RE: GRAND MATE CO., LTD

FCC ID: UMP650

After a review of the submitted information, I have a few comments on the above referenced Application.

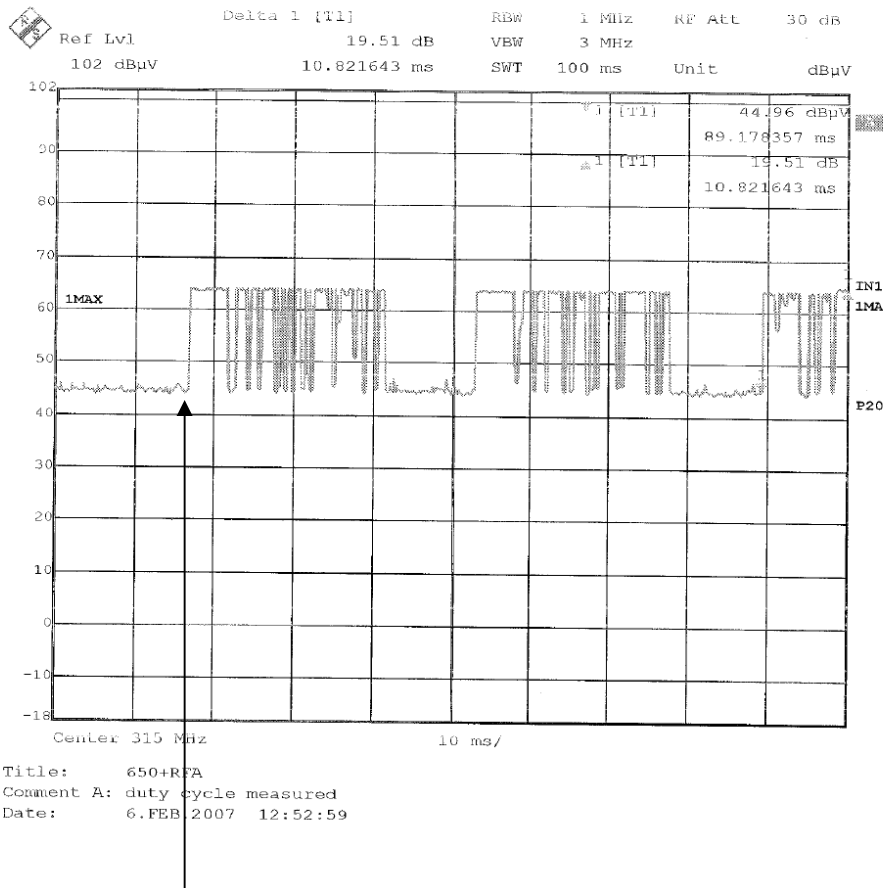
- 1) FYI.....Please note that method for showing average calculation is not quite correct. However since compliance is still shown even if recalculated – further actions is not necessary.

If 100 msec period started here, then TX time would be $25.02 * 3$ in 100 msec. Additionally, please note that the 25.02 TX periods could be further reduced if worse case encoding is known. However without knowing this, use of 25.02 seems appropriate. Therefore it appears that correction factor should be $20 \log (.2502*3) = 2.48$ instead of 4.3 dB.
